Access Compliance Report

Public Rights-of-Way

(Curb Ramps)

Intersection ID: N/A	Main Street: HARGROVE_AV	Cross Street: N/A	Location: SW
ADA ID: 7ED968A9C0FF	Ramp Type: PerpDiag	Initial Pass/Fail: Fail	Overall Compliance: No
Severity Score: 25			
Codes/Mitigation Info/Possible Solution		Field Measurements/Component Compliance

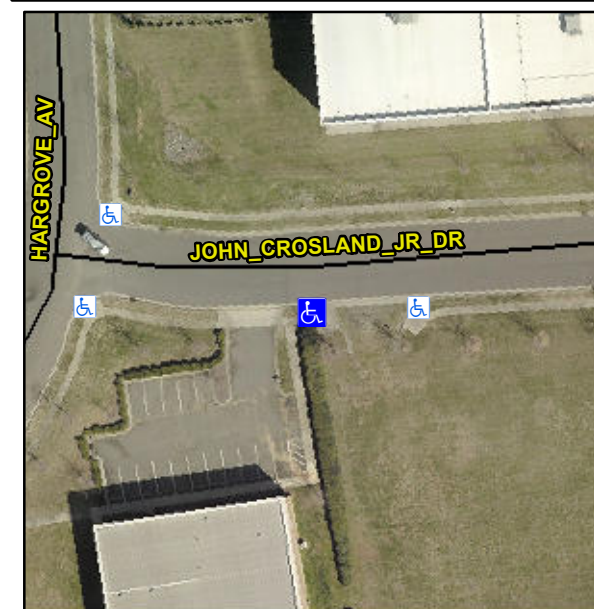
R304.5.3

Compliance	Description	Data	Compliance	Description	Data
N/A	Ramp Length (in)	60.0	Yes	Ramp Slope (%)	7.2
Yes	Ramp Width (in)	54.0	No	Ramp XSlope (%)	7.8
N/A	Flare Type LT	N/A	N/A	Flare Type RT	N/A
N/A	Flare Slope LT (%)	N/A	N/A	Flare Slope RT (%)	N/A
N/A	Flare Traversable LT?	No	N/A	Flare Traversable RT?	No
N/A	Landing Length (in)	N/A	N/A	DWS Provided?	N/A
N/A	Landing Width (in)	N/A	N/A	DWS Contrast?	N/A
N/A	Landing Slope (%)	N/A	N/A	DWS Length (in)	N/A
N/A	Landing X Slope (%)	N/A	N/A	DWS Full Width?	N/A
N/A	Landing Curb? (Y/N)	N/A	N/A	DWS Offset (in)	N/A
N/A	Shared Landing?	N/A			
N/A	Gutter Ponding?	N/A	N/A	Gutter Slope (%)	N/A
N/A	Gutter Lip Ht (in)	N/A	N/A	Gutter X Slope (%)	N/A
N/A	Painted X Walk1?	No	N/A	Painted X Walk2?	No
	X Walk 1 Direction	To E		X Walk 2 Direction	To N
N/A	X Walk 1 Width (in)	N/A	N/A	X Walk 2 Width (in)	N/A
	X Walk 1 Slope (%)	N/A		X Walk 2 Slope (%)	2.5
	X Walk 1 X Slope (%)	N/A		X Walk 2 X Slope (%)	2.3

Remove & Replace Curb Ramp With Two New Directional Ramps or Equivalent.
